REVIEW COMMENTS ON SHEETS 4, 5 AND 13  
AND RESUBMIT THROUGH THE PERMIT  
CENTER WITH REVISION APPLICATION  
COMPLETED WITH REVISION FORM

## ***Structural Calculations***

Red Dot Corporation  
Environmental Chamber Framing Re-Use  
2220760.20

**S1.0**

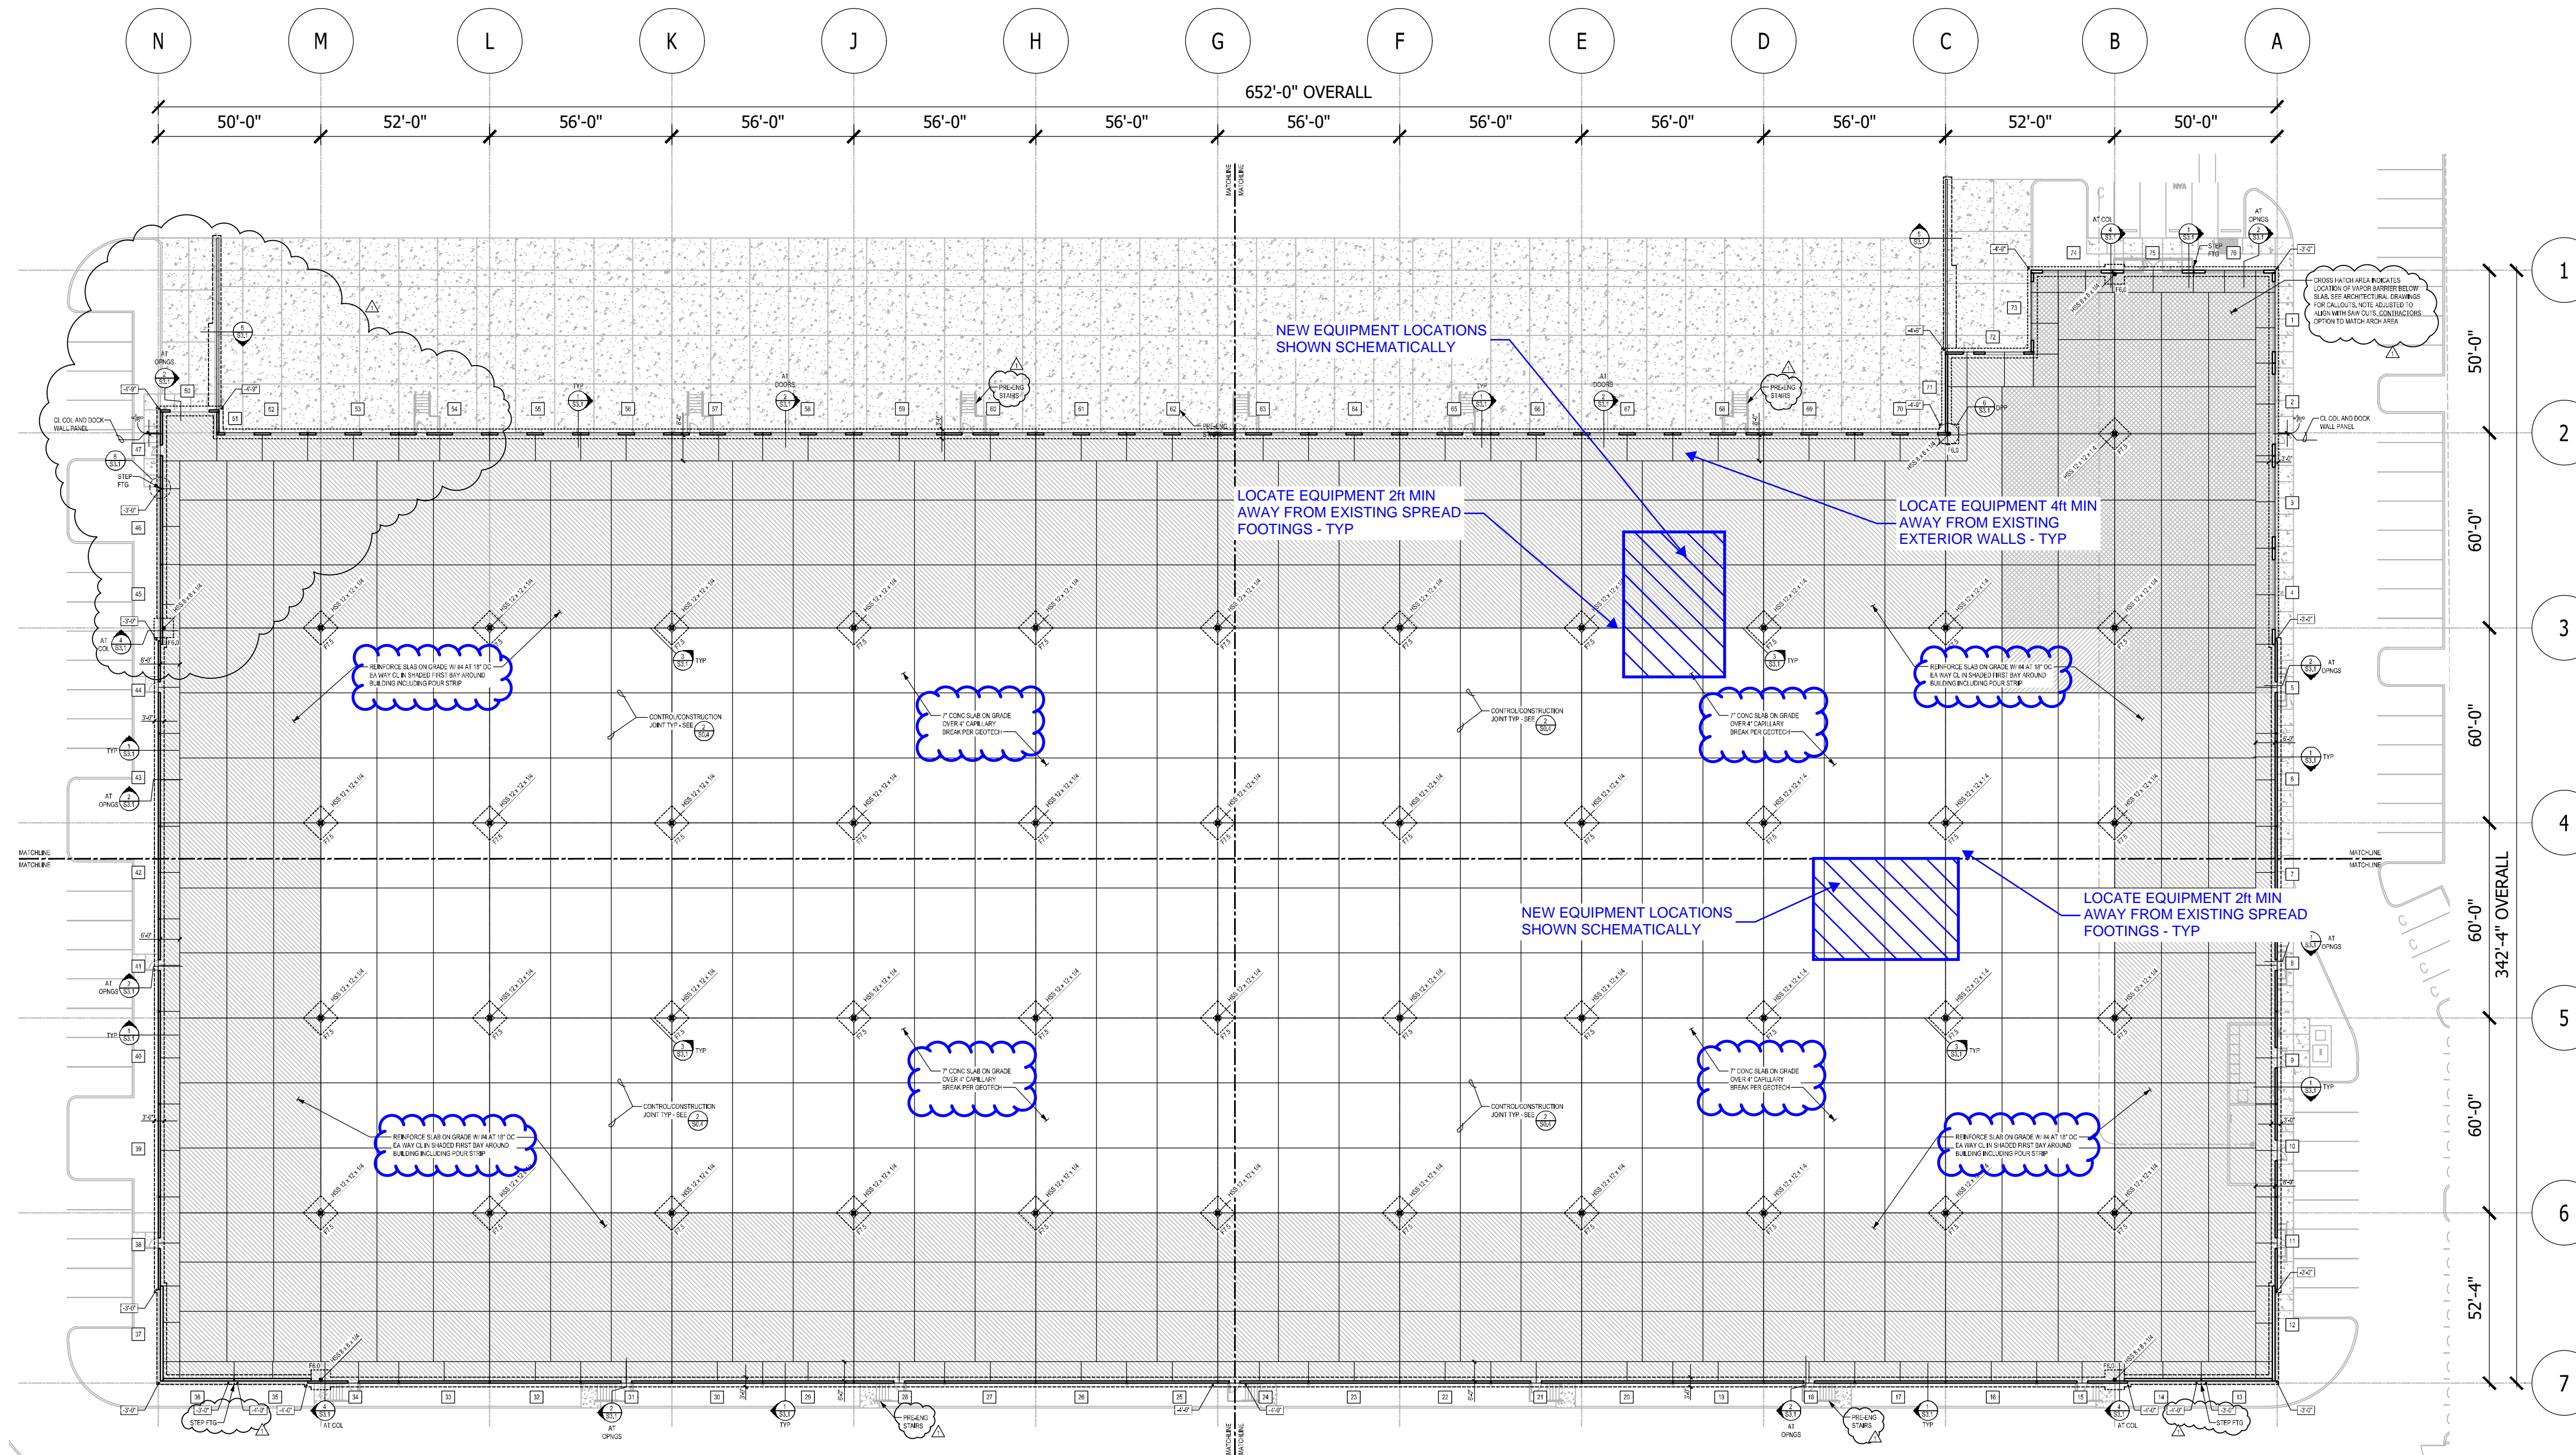
Provide location of placement of the Environmental Chamber on foundation plan to indicate where it will be installed.  
Page S1.0
